Contract No. TS-900
West Rail : Environmental Impact Assessment
Final Landscape Design Strategy Report - Volume I

West Rail
Final Landscape Design Strategy Report

Annex A : Response to Comments

Fig. 2A
Plan of West Rail

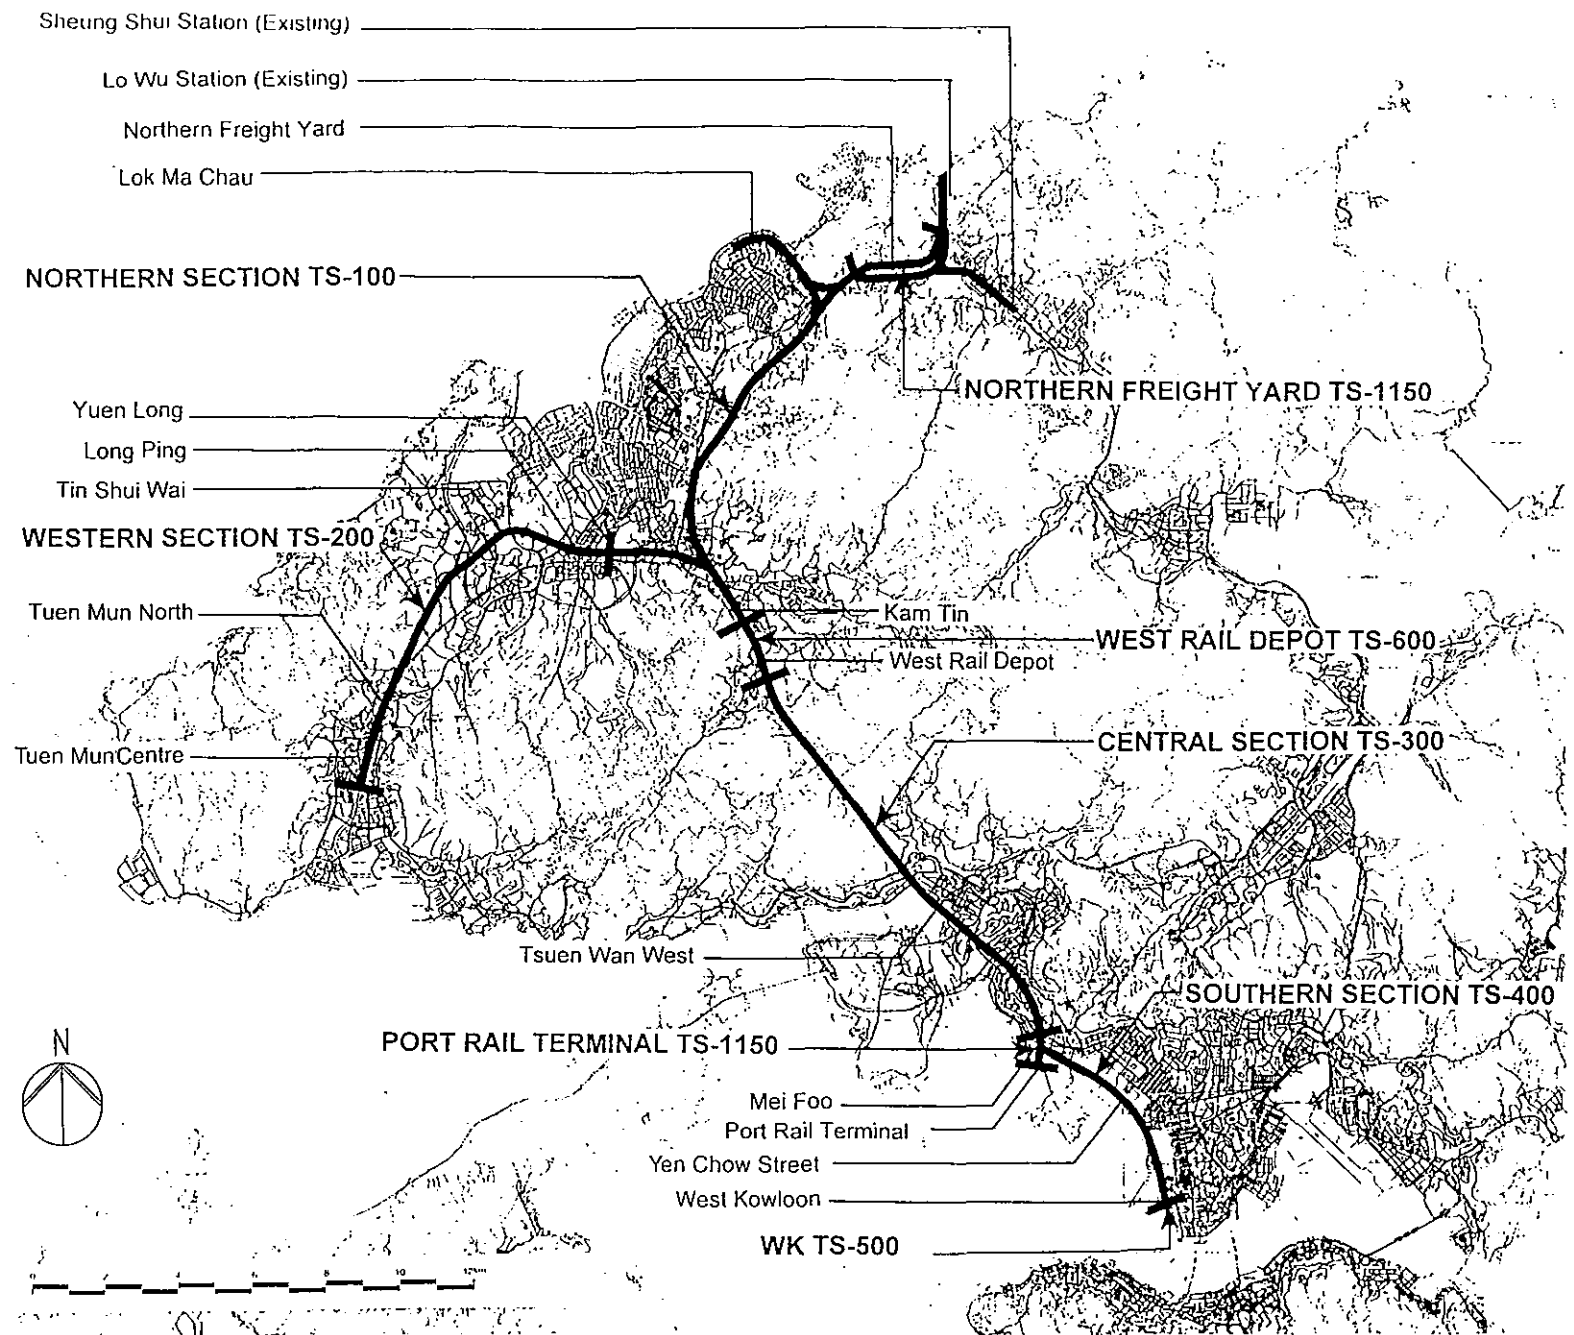
| ITEM NO. | REVIEW BY | DOCUMENT REFERENCE | WEST RAIL COMMENT | CONSULTANT RESPONSE | ACTION (I or D) | DUE DATE | CLOSE DATE |
|----------|-----------------------|---|---|--|-----------------|----------|------------|
| 13 | HyD, Stephen Ching | Figure 2A (page 2.03) | For clarity purposes, legends should be used to differentiate the boundaries of each of the Technical Studies. | Noted and amended accordingly. | | | |
| 14 | HyD, Stephen Ching | Figure 2A (page 2.03) and Figure 2B (page 2.04) | The West Rail alignment leading to Lok Ma Chau (LMC) Terminal and the location of the LMC Terminal shown in these Figures should be in line with that shown on pages 4.29, 4.32, 4.40 and 4.57. | Noted and amended accordingly. | | | |

Fig. 4C West Rail Depot (TS600)

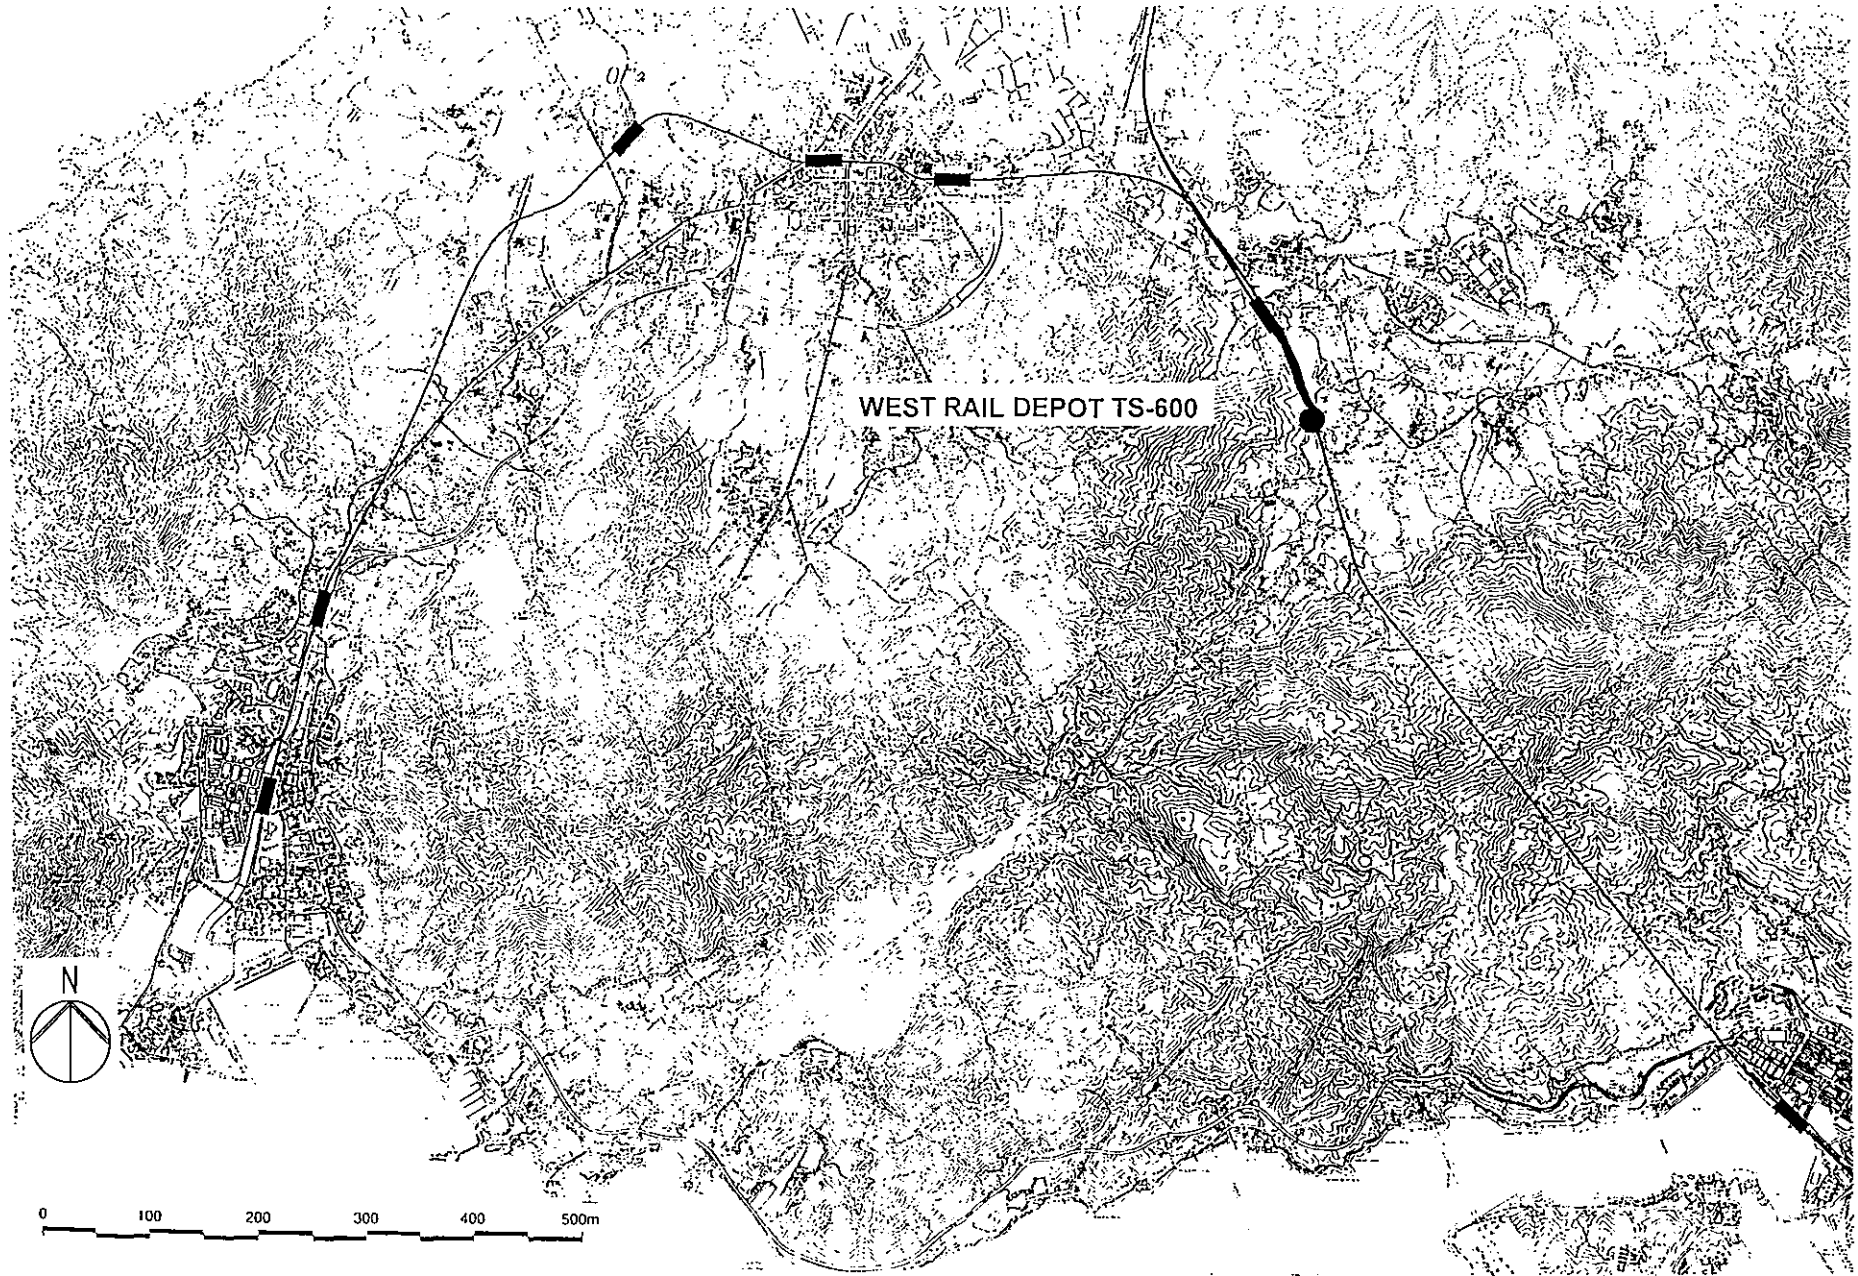
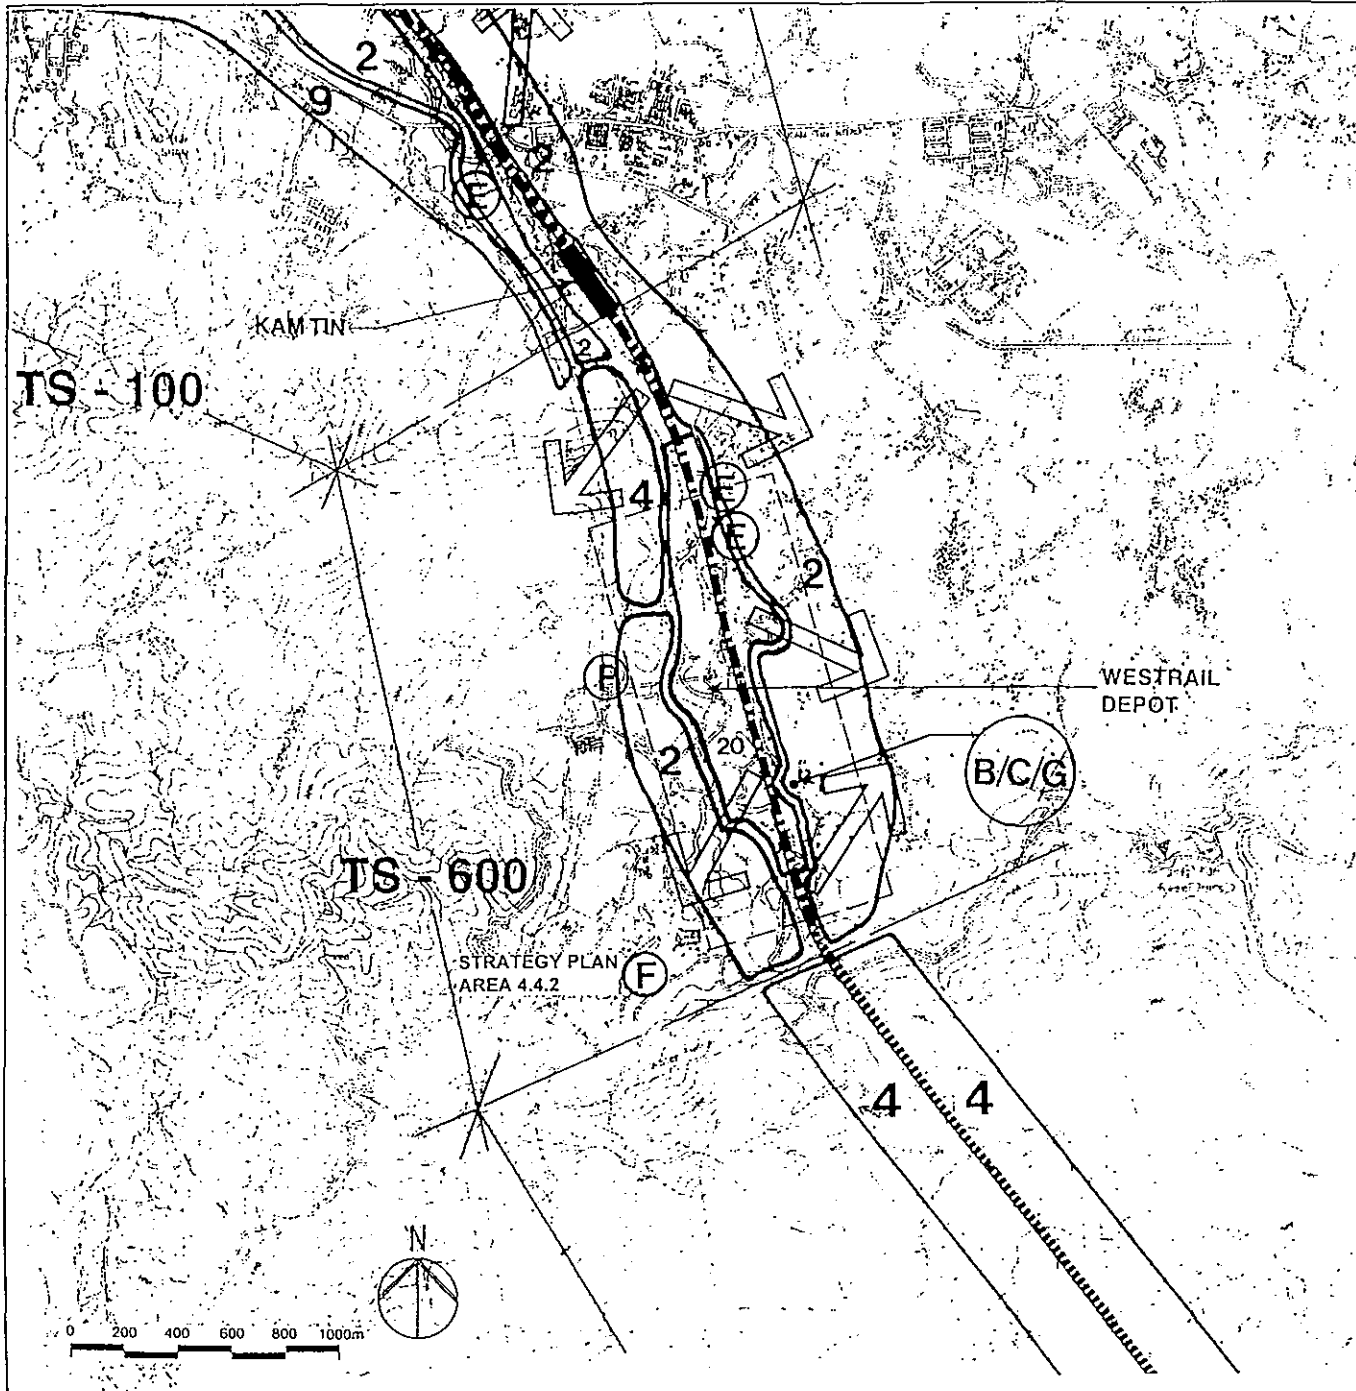
| ITEM NO. | REVIEW BY | DOCUMENT REFERENCE | WEST RAIL COMMENT | CONSULTANT RESPONSE | ACTION (I or D) | DUE DATE | CLOSE DATE |
|----------|-----------|---|---|---|-----------------|----------|------------|
| 96 | AN | p.4.25 Fig.4C | Pls revise the layout of the depot according to the latest information. | TS-600 engineers to forward latest layout. | | | |

Fig. 4E Western Section (TS200)

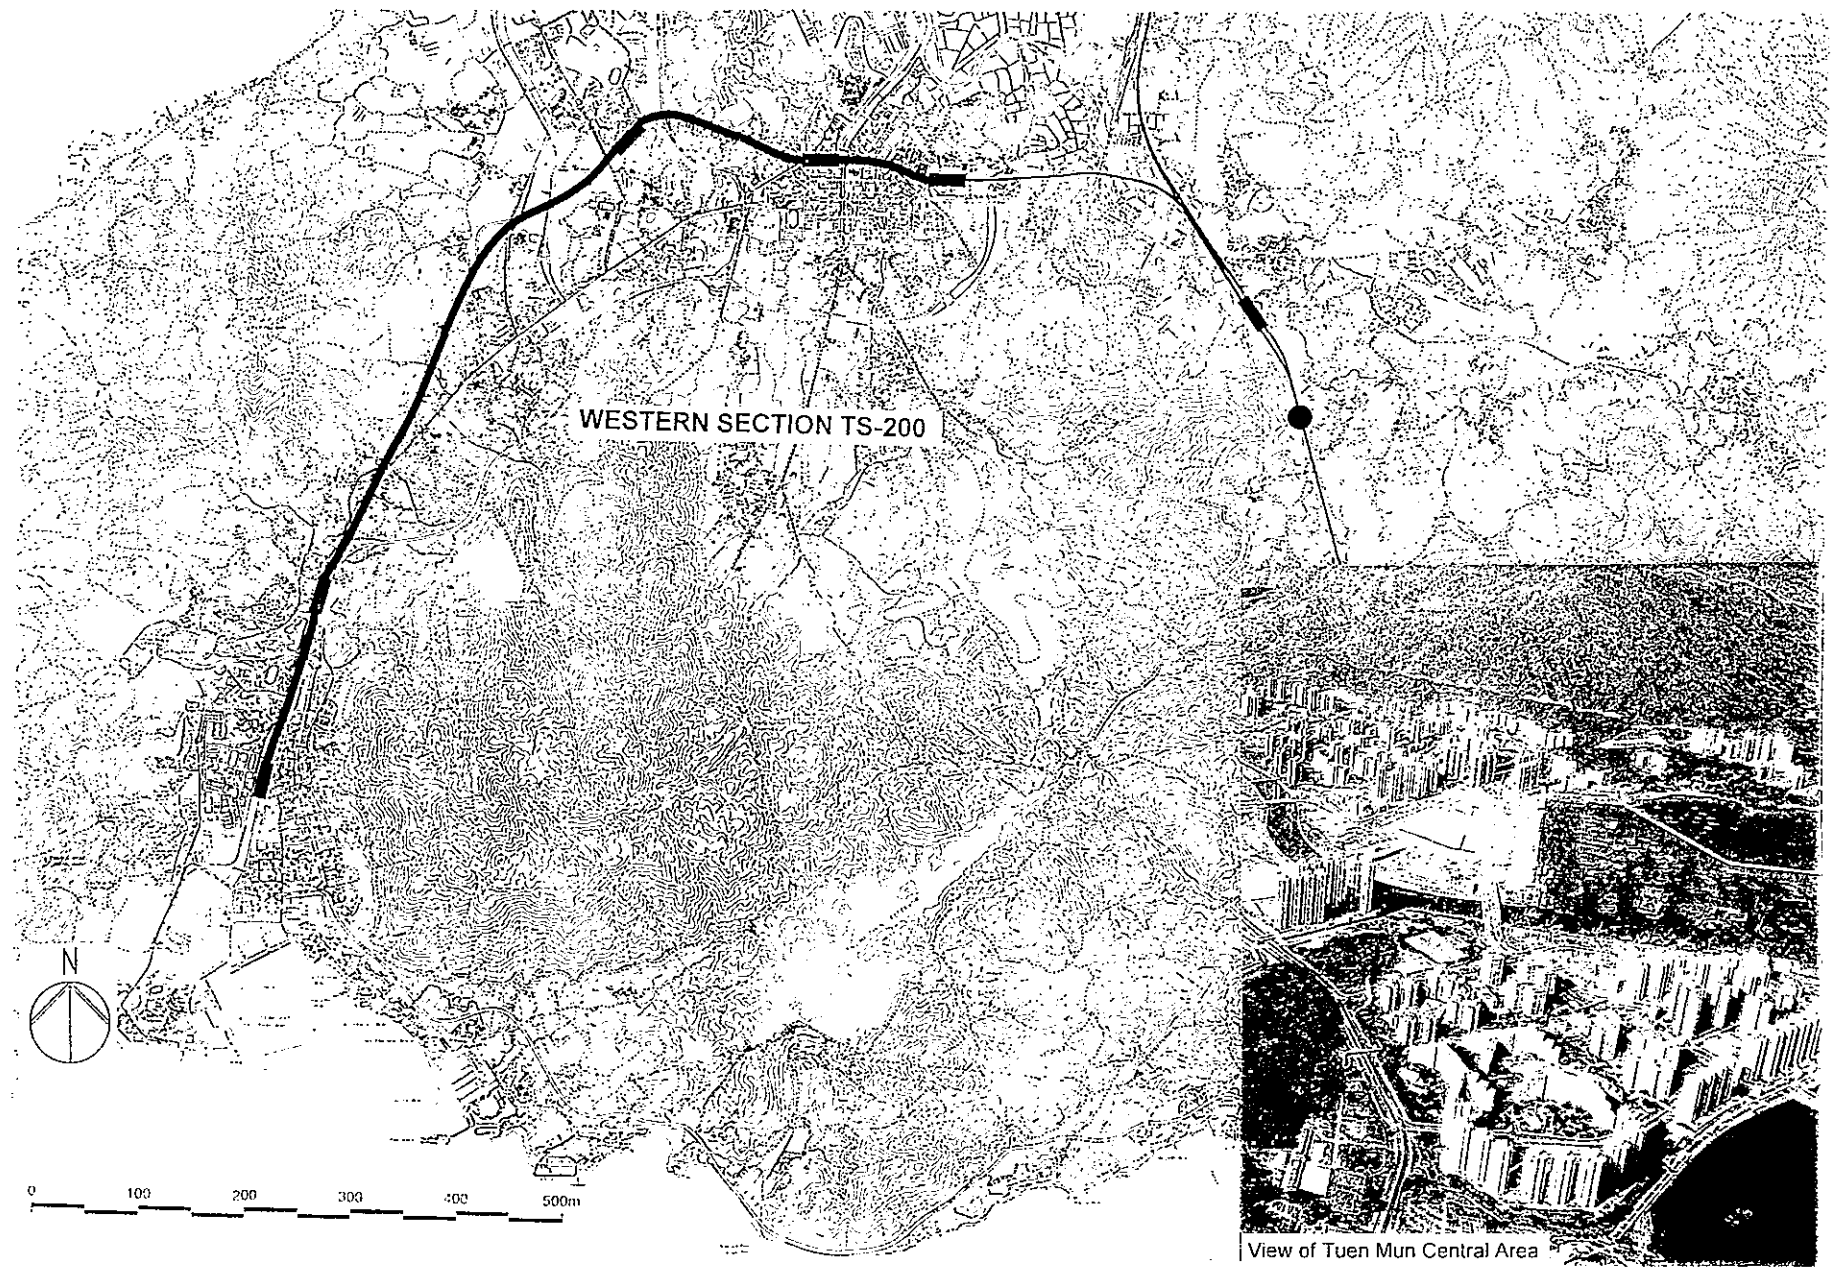
| ITEM NO. | REVIEW BY | DOCUMENT REFERENCE | WEST RAIL COMMENT | CONSULTANT RESPONSE | ACTION (I or D) | DUE DATE | CLOSE DATE |
|----------|--------------------|---------------------------------|--|--|-----------------|----------|------------|
| 19 | HyD, Stephen Ching | Figure 4E (page 4.45) | TS-200 for the Western Section does not include the section of the branch line from the main line at Au Tau to the east wall of Yuen Long Station. Therefore, this section should not be marked in "bold". | Noted and amended accordingly | | | |
